IEC/TC or SC: CISPR/I	Project number CISPR 22 am3 f1 Ed. 5.0	
Title of TC/SC: EMC of Information technology, multimedia equipment and receivers	Date of circulation 2008-02-08	Closing date for comments 2008-05-09
Also of interest to the following committees	Supersedes document CISPR//89/CD, CISPR//145/NP, CISPR//156/RVN	
Functions concerned: <input type="checkbox"/> Safety <input checked="" type="checkbox"/> EMC	<input type="checkbox"/> Environment <input type="checkbox"/> Quality assurance	
Secretary: Takashi YAMAGUCHI - Japan	THIS DOCUMENT IS STILL UNDER STUDY AND SUBJECT TO CHANGE. IT SHOULD NOT BE USED FOR REFERENCE PURPOSES. RECIPIENTS OF THIS DOCUMENT ARE INVITED TO SUBMIT, WITH THEIR COMMENTS, NOTIFICATION OF ANY RELEVANT PATENT RIGHTS OF WHICH THEY ARE AWARE AND TO PROVIDE SUPPORTING DOCUMENTATION.

Title:
CISPR22 - Limits and method of measurement of broadband telecommunication equipment over power lines

2. Proposal for amendment to CISPR 22, Edition 5.2

Figure C.5: Compliance test set-up for 1605 kHz to 30 MHz when the telecommunication function is active

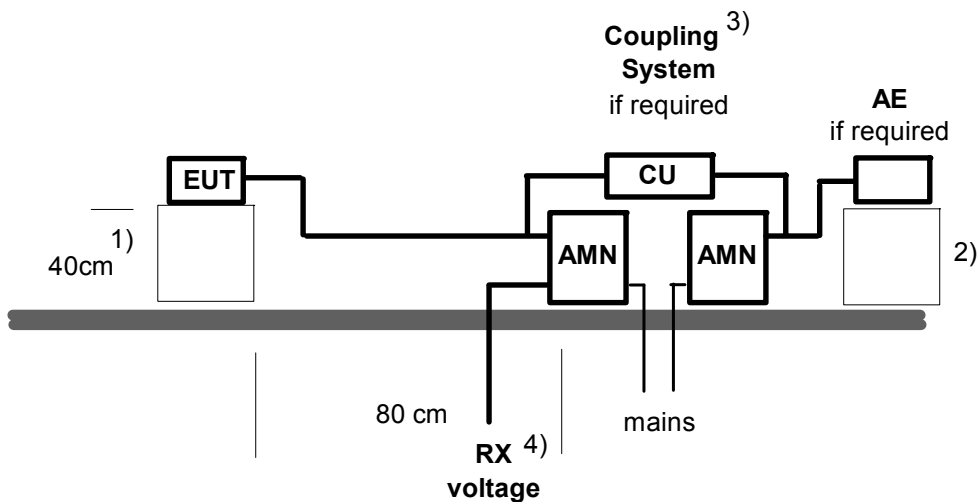
Add Figures C.5; C.6; and C.7 to look as follows:

- 1) Distance to the reference ground plane (vertical or horizontal)
- 2) Distance to the reference ground plane is not critical
- 3) Functions of the Coupling set-up:
 - stabilization of the differential mode impedance
 - isolation of the differential- and common mode signal of the AE
 - filtering of the differential- and common mode signal from the mains
- 4) ISN voltage for 1605 kHz and 30 MHz (if applied)

Figure C.6: Compliance test set-up for PLT for 150 kHz to 1605 kHz

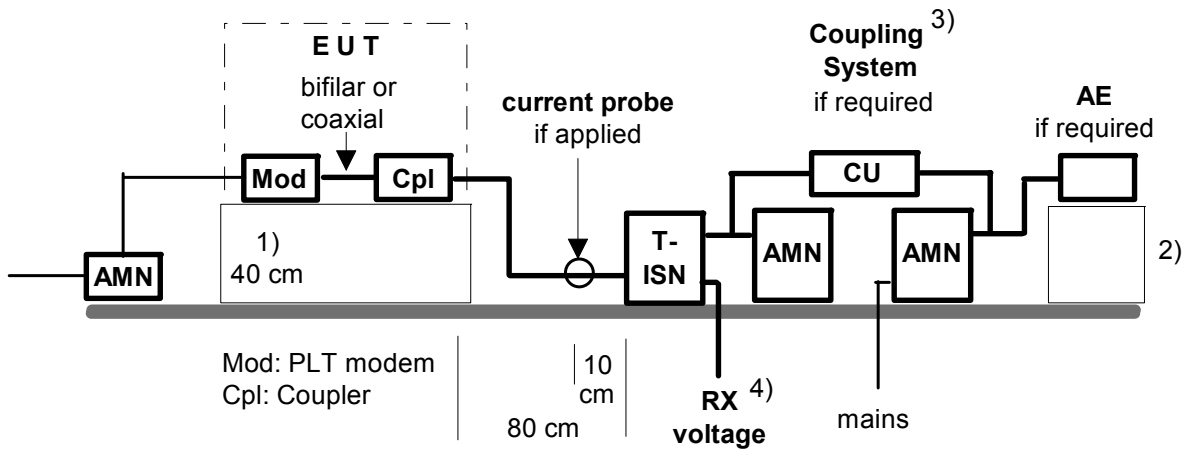
- 1) Distance to the reference ground plane (vertical or horizontal)
- 2) Distance to the reference ground plane is not critical
- 3) Functions of the Coupling set-up:
 - stabilization of the differential mode impedance
 - isolation of the differential- and common mode signal of the AE
 - filtering of the differential- and common mode signal from the mains
- 4) AMN voltage

Figure C.8: Coupling System to mains and AE

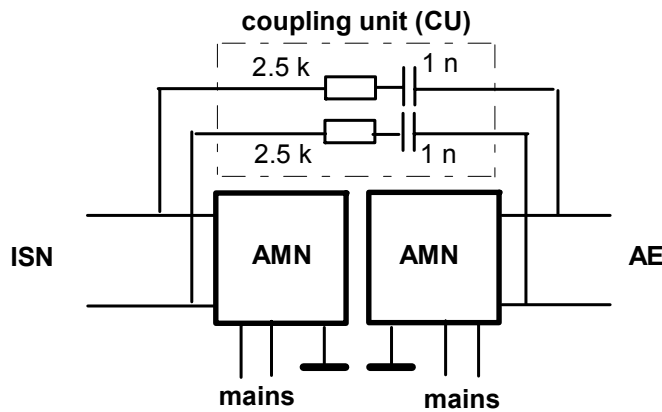
- 1) Distance to the reference ground plane (vertical or horizontal)
- 2) Distance to the reference ground plane is not critical
- 3) Functions of the Coupling set-up:
 - stabilization of the differential mode impedance
 - isolation of the differential- and common mode signal of the AE
 - filtering of the differential- and common mode signal from the mains
- 4) ISN voltage for 1605 kHz and 30 MHz (if applied)

Figure C.7: Compliance test set-up for PLT devices with separate coupler for 1605 kHz to 30 MHz when the telecommunication function is active

Change "Figure C.10 - flowchart for selecting test method" to look as follow:

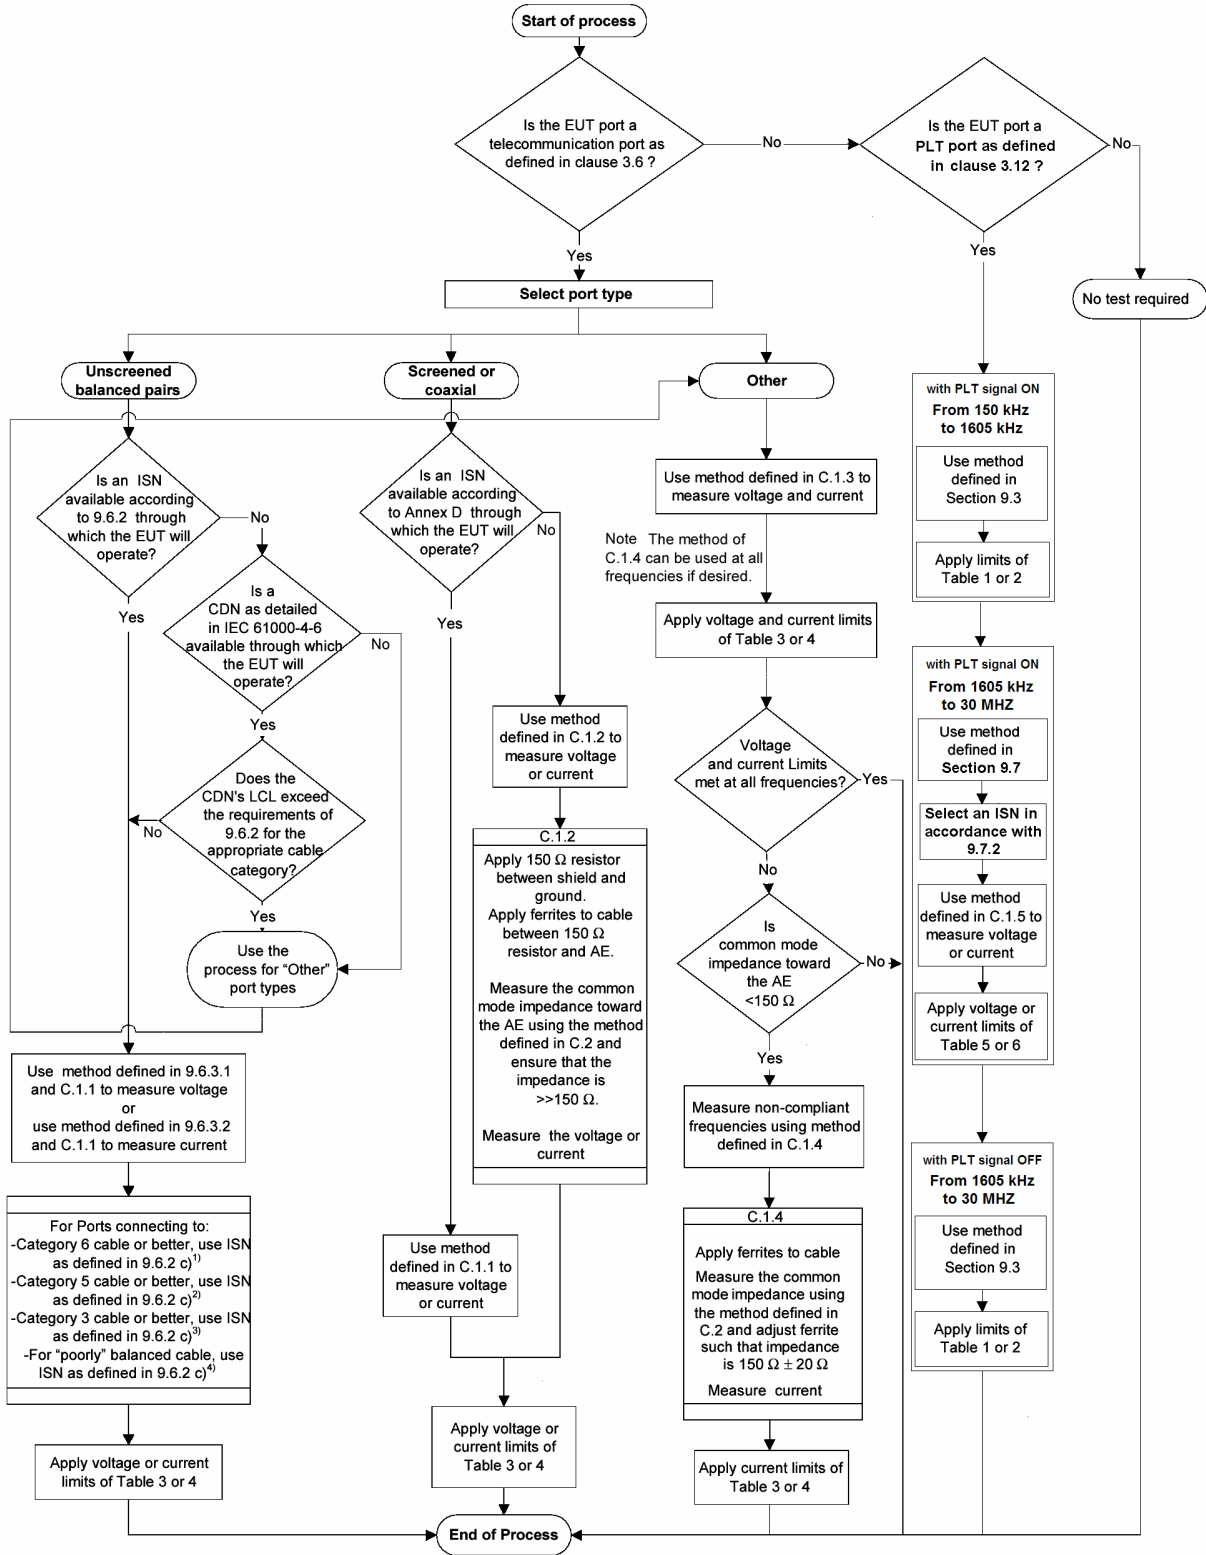
Renumber "Figure C.6 - flowchart for selecting test method" to:
 "Figure C.10 - flowchart for selecting test method"

Figure H.1 Differential mode ISN transmission loss measurement set-up

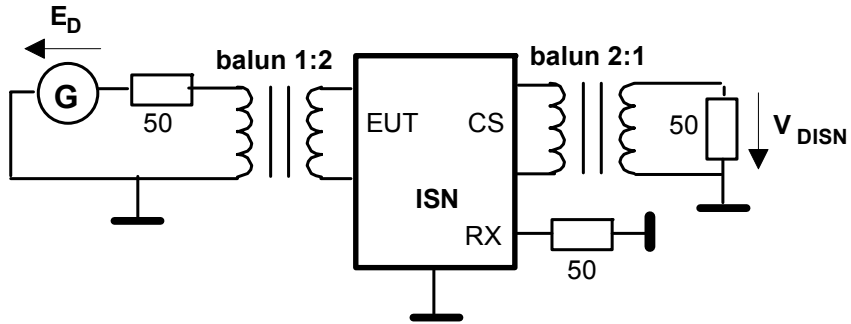
- c) The differential mode transmission loss of the ISN (excluding the Coupling System) shall be $a_{DISN} = 20 \log (E_D / (2 * V_{DISN})) \leq 3$ dB (The measurement set-up is shown in Figure H.1)

Figure H.2 Common mode ISN transmission loss measurement set-up

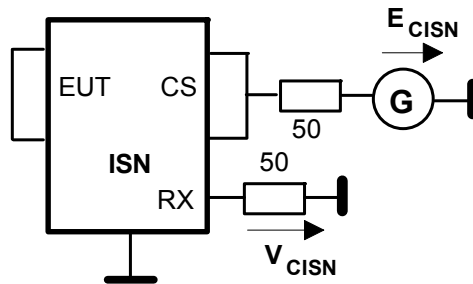
- d) The common mode transmission loss of the ISN (excluding the Coupling System) between the AE port and the measurement port shall be $a_{CISN} = 20 \log (E_{CISN} / (2 * V_{CISN})) > 14$ dB (The measurement set-up is shown in Figure H.2)

Figure H.3 Differential mode Coupling System transmission loss measurement set-up

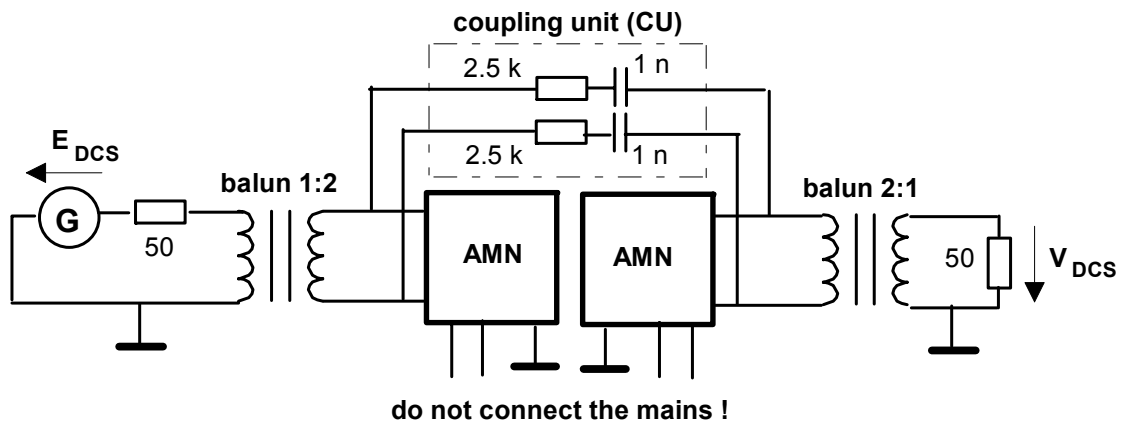
The differential mode transmission loss of the Coupling System should be
 $a_{DCS} = 20 \log (E_{DCS} / (2 * V_{DCS})) > 40 \text{ dB} \pm 6 \text{ dB}$; (The measurement set-up is shown in Figure H.3)

Figure H.4 Common mode Coupling System transmission loss measurement set-ups

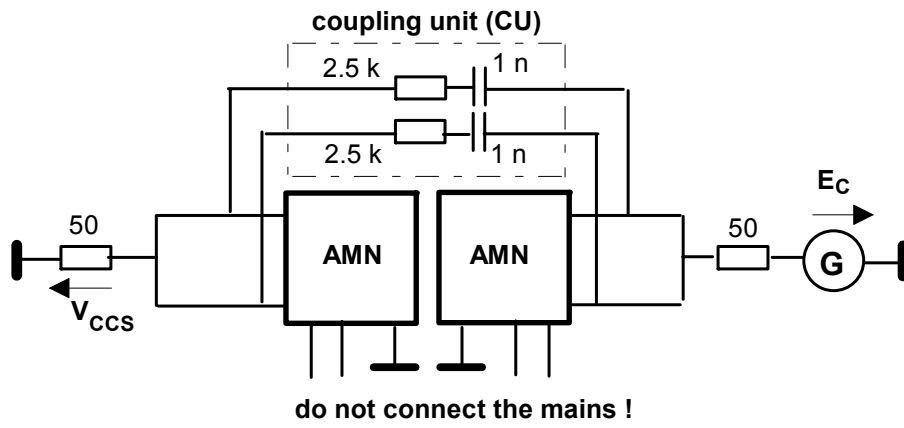
The common mode transmission loss of the coupling System should be
 $a_{CCS} = 20 \log (E_C / (2 * V_{CCS})) > 40 \text{ dB}$; (The measurement set-up is shown in Figure H.4)
